CONDITIONS OF APPROVAL:

Engineering - PUD Plan Checklist

Shadow Green Dev Plan_2.6.2017.pdf

42. Emergency Access Gates

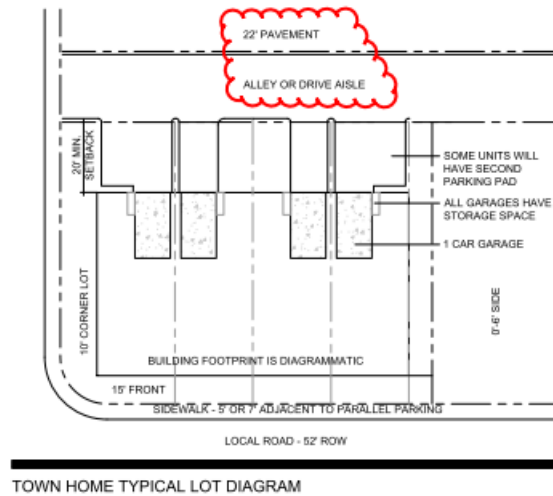
joe.marlo@franklintn.gov Applicant to revise the grading to provide a 50-foot length of road on each side of the access gates with a minimal (2% maximum) slope. The gates are to located to be fully on the City of Franklin property to the north. Revise the gate note on C2.0 to state the following: *"Applicant to provide security gates for emergency access and to revise existing fencing layout to accommodate gates. Gate and fencing design to be approved by the City of Franklin and be coordinated at site plan."*

65. Sidewalks

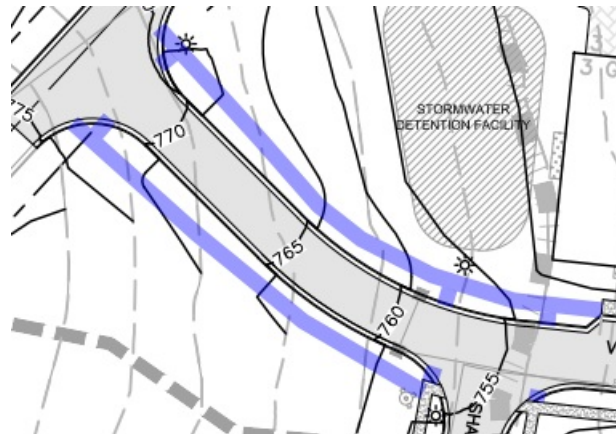
joe.marlo@franklintn.gov This is a newcomment based on newinformation shown on the drawings.

Applicant to show the sidewalks along Vintage Green Lane to the future access road that have been removed in the most recent submittal. No sidewalks are to be shown along the future access road itself. Provide sidewalk connections from Shadow Green Drive as schematically shown below.

61. Parking Area

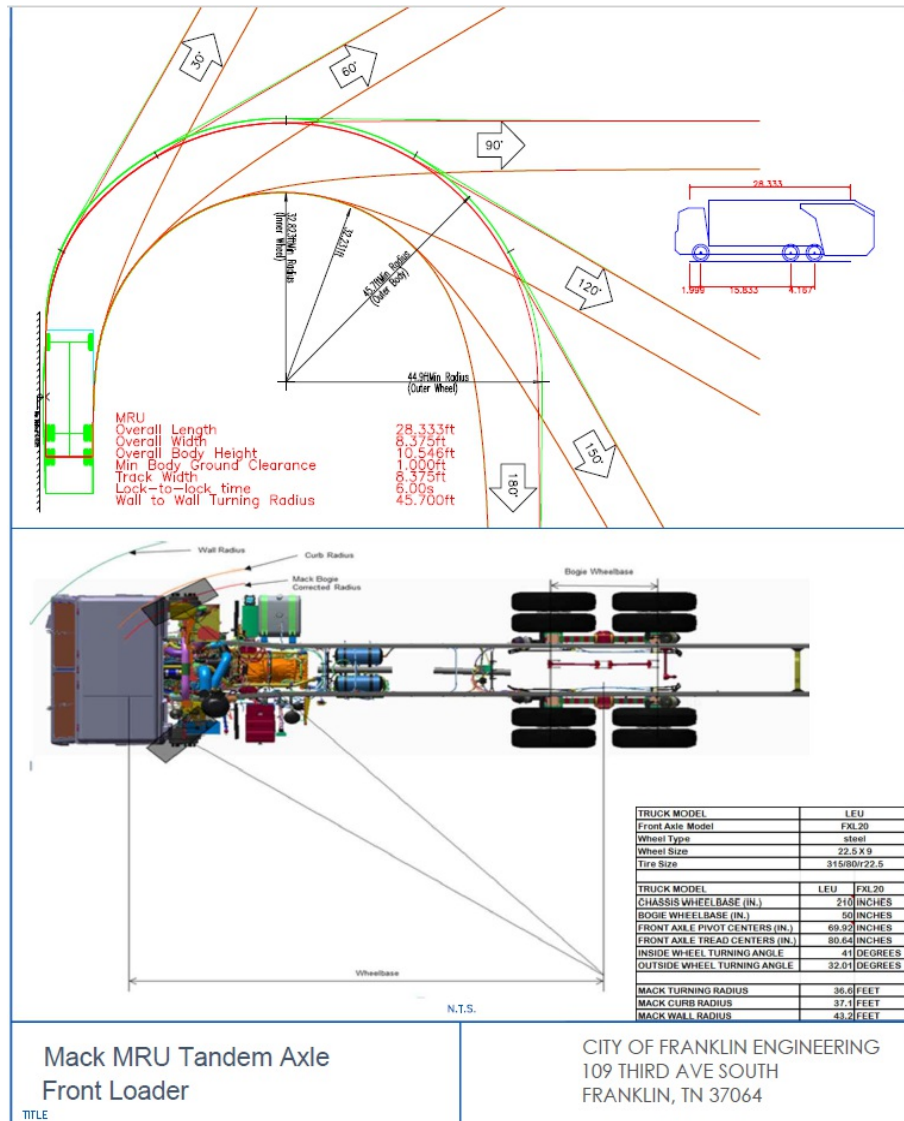
larry.mizell@franklintn.gov The large parking area in the core shall at site plan be redesigned so as to make it look forested and not amass of parking.
